**Re: NOI - DEP File #007-2208
176 Scraggy Neck Road
Map 51, Parcel 1
Bourne, Massachusetts**

**RE: Supplemental Information for Notice of Intent
176 Scraggy Neck Road
Bourne, MA 02532**

**EXISTING CONDITIONS PLAN
 IN BOURNE, MA**
 Prepared For:
**STEPHEN & MARYBETH BISSON
 TRUSTEES OF THE LONG
 POINT TRUST**
 #176 SCRAGGY NECK ROAD
 MAP 51 PARCEL 1 (LOT 2)

PROPOSED SITE PLAN
IN BOURNE, MA
Prepared For:
STEPHEN & MARYBETH BISSON
TRUSTEES OF THE LONG POINT TRUST
#176 SCRAGGY NECK ROAD
MAP 51 PARCEL 1 (LOT 2)

SEPTIC DETAILS
 IN BOURNE, MA

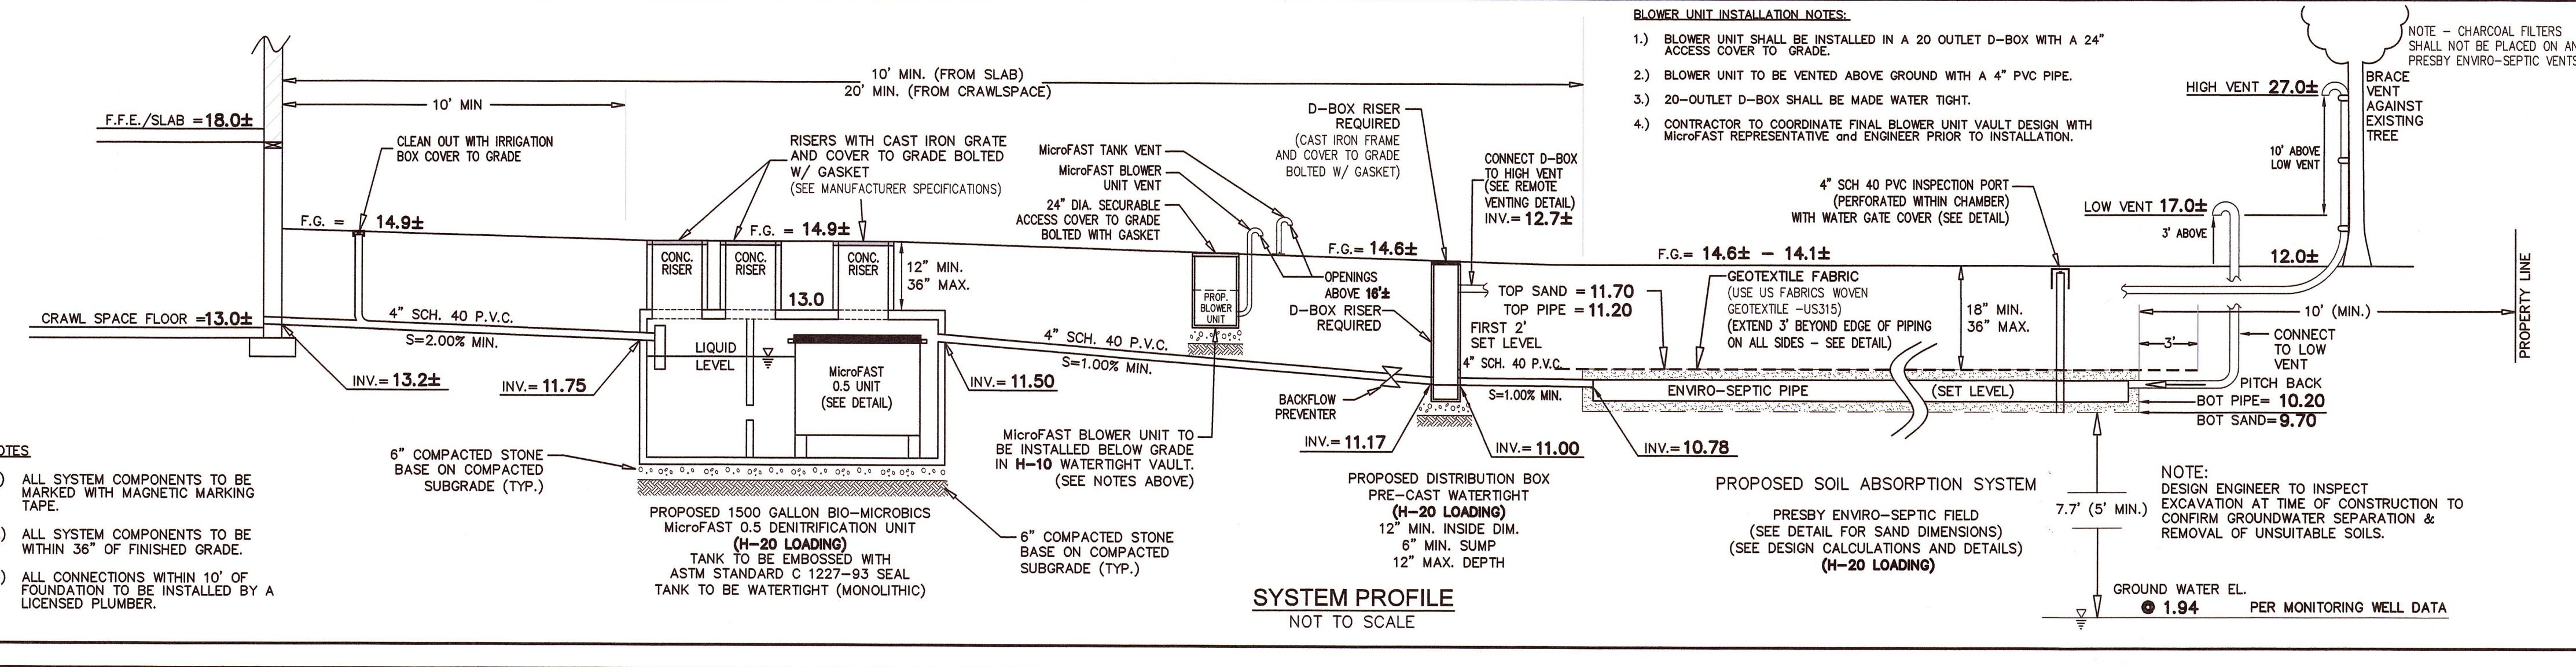
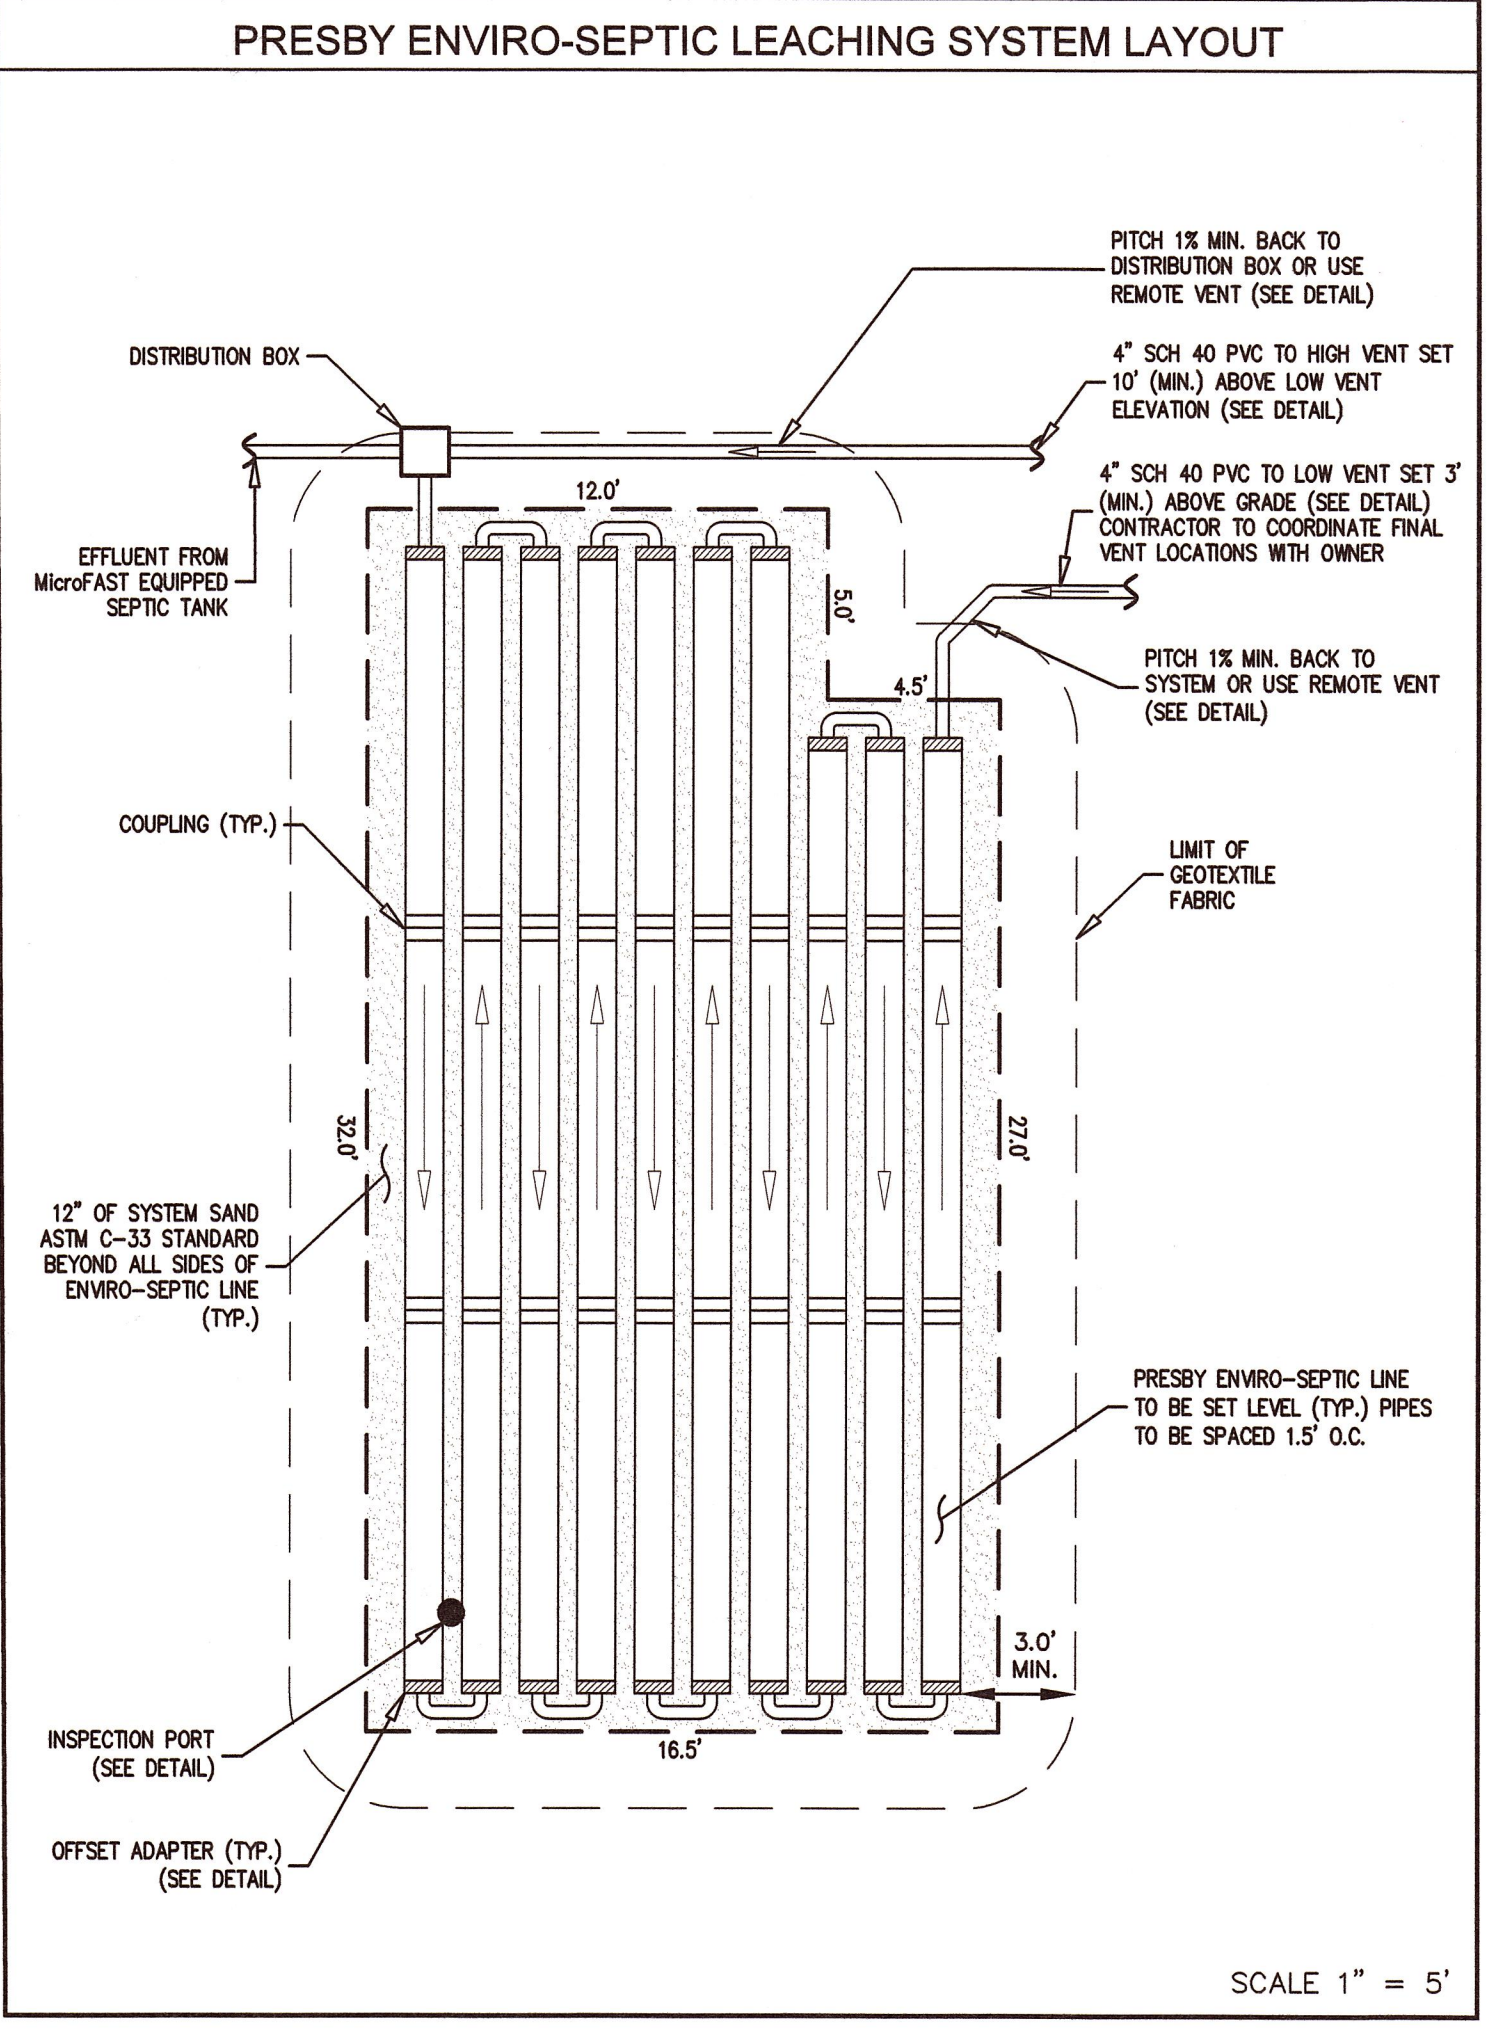
No.	Date	Revision Description	By
3	9/26/22	REVISE SEPTIC DETAIL LAYOUT	JPH
2	8/22/22	REVISE SEPTIC LAYOUT, MISC. DETAILS	JPH
1	6/14/22	REVISE SEPTIC LAYOUT, MISC. DETAILS	JPH

PROPOSED SITE EXHIBIT
 IN BOURNE, MA
 Prepared For:
STEPHEN & MARYBETH BISSON
 TRUSTEES OF THE LONG POINT TRUST
 #176 SCRAGGY NECK ROAD
 MAP 51 PARCEL 1 (LOT 2)

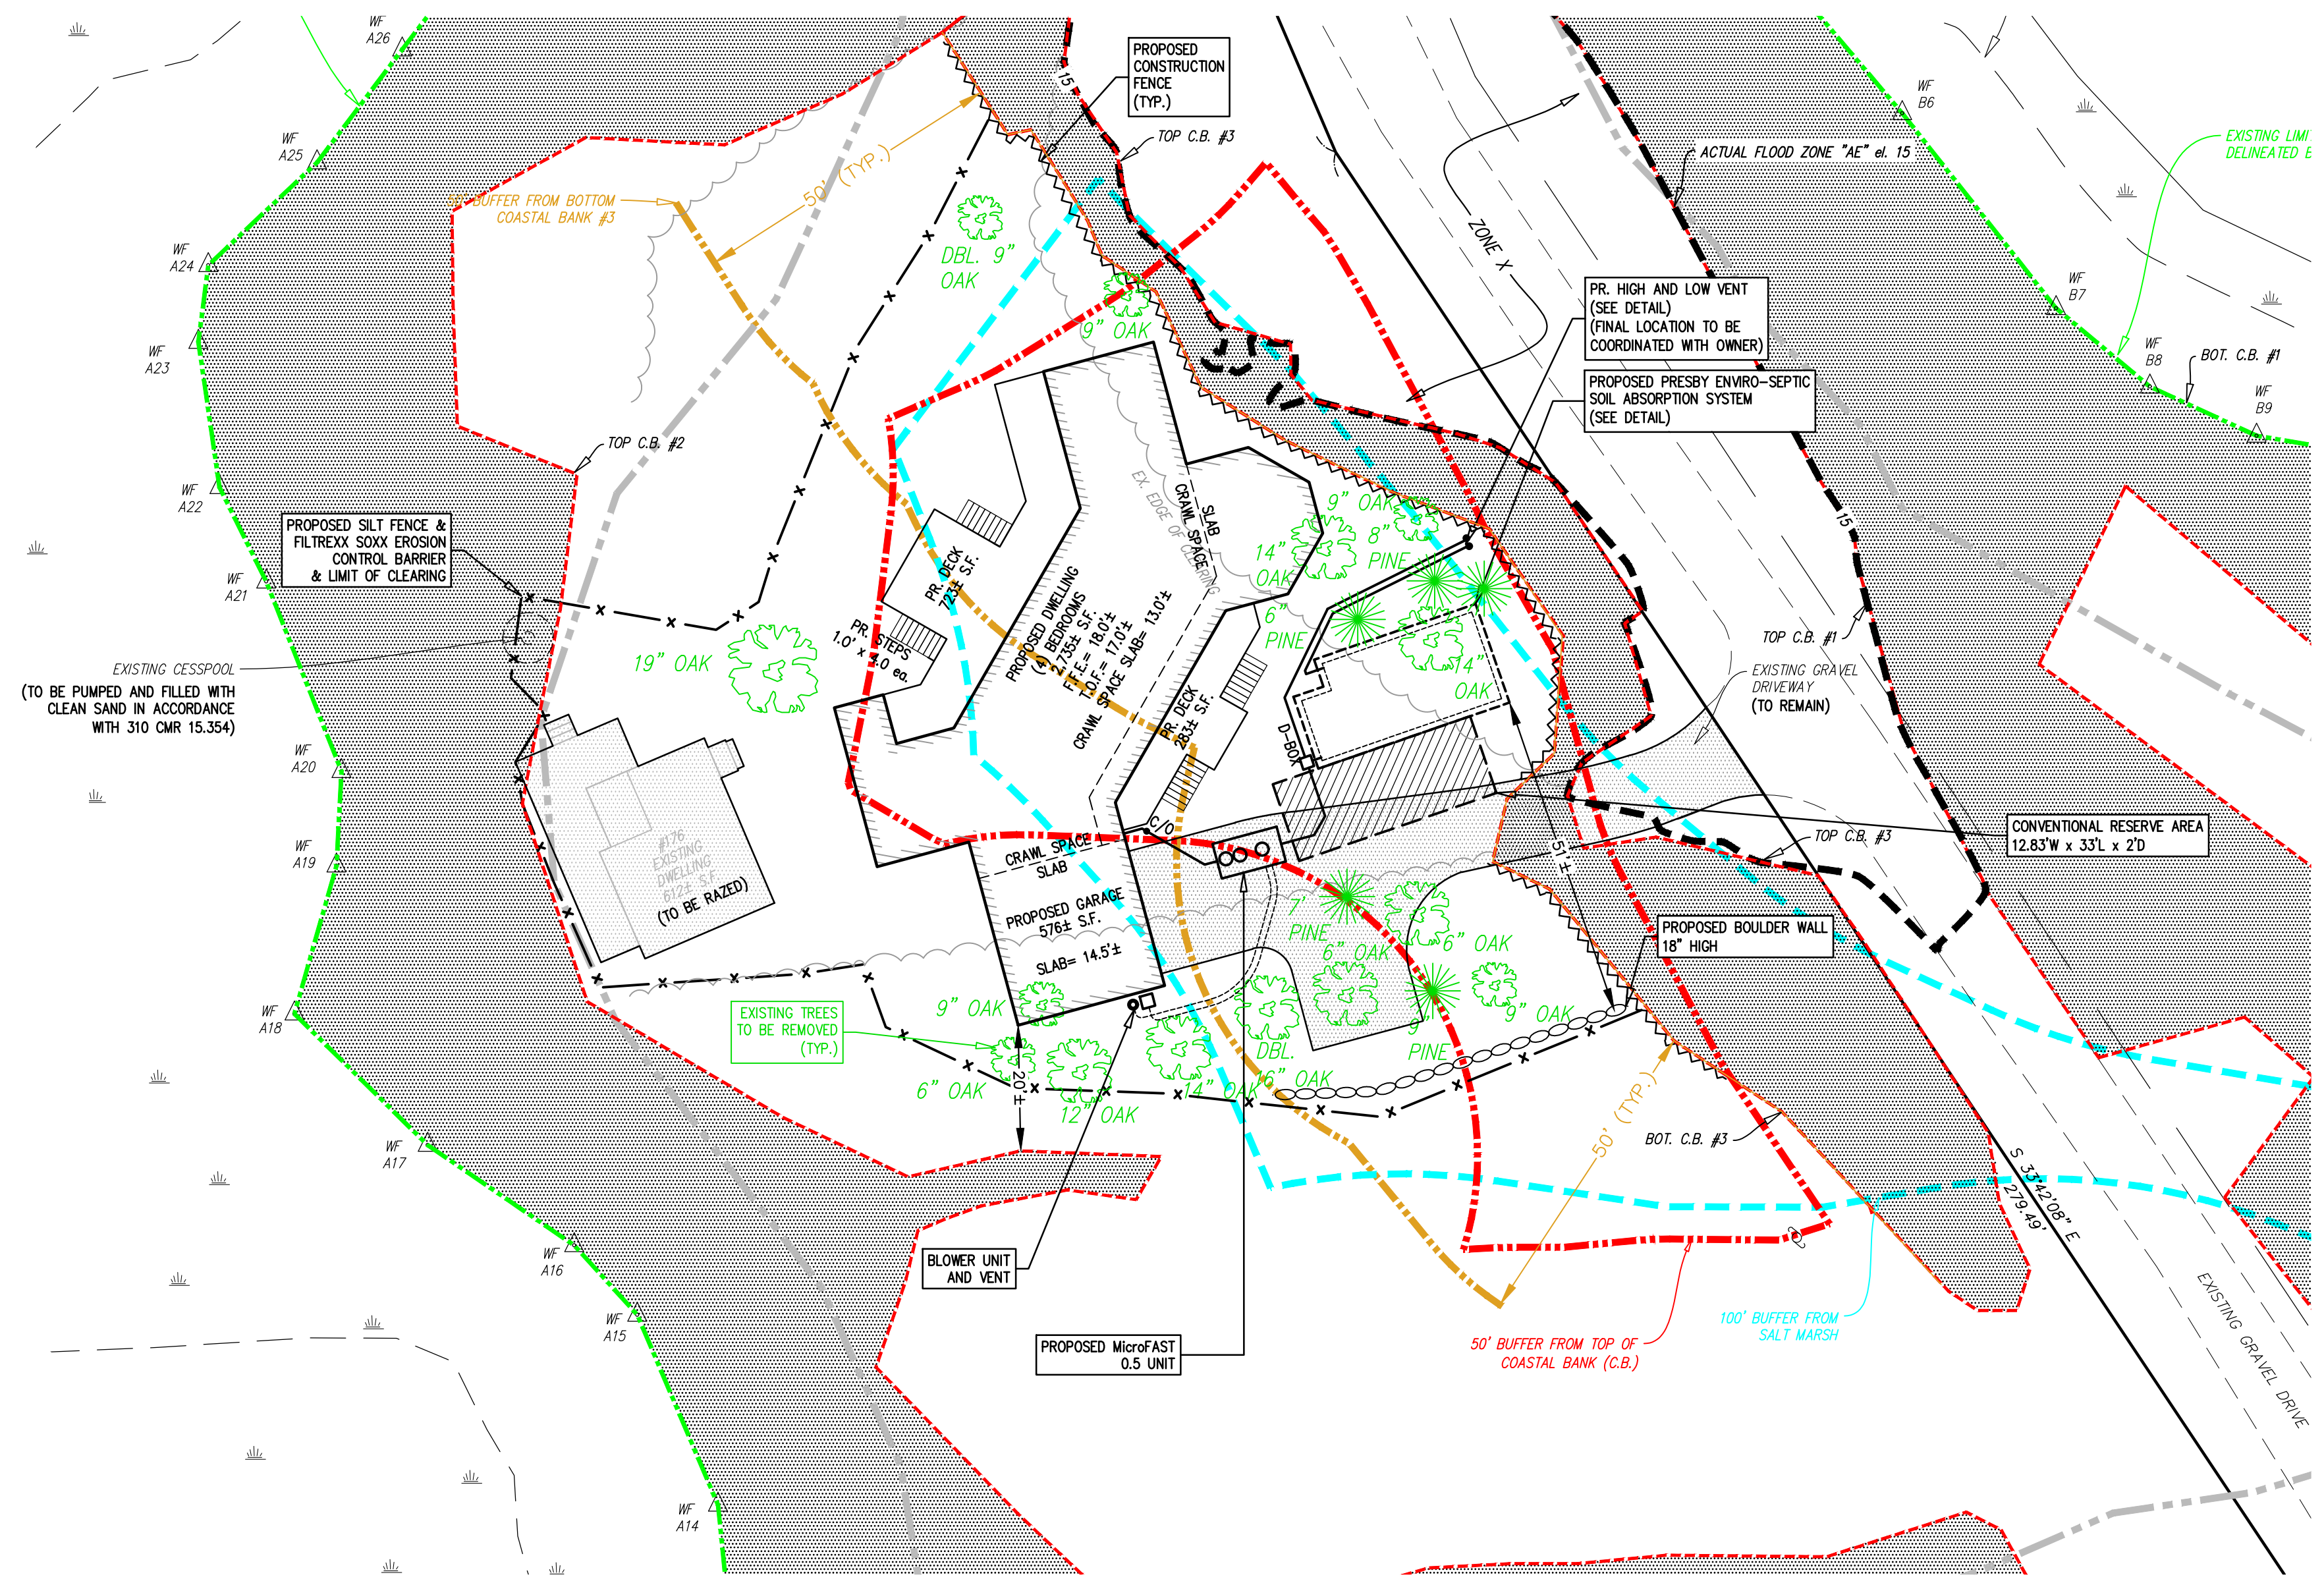
The *Proposed Site Exhibit*, prepared by Bracken Engineering, Inc., dated September 26, 2022, depicts the trees proposed to be removed within the Limit of Work. A total of nineteen (19) trees are proposed to be removed, fifteen (15) oaks (6-19" dbh) and five (5) pines (6-9" dbh). Only five trees are at 12 inch dbh or greater.
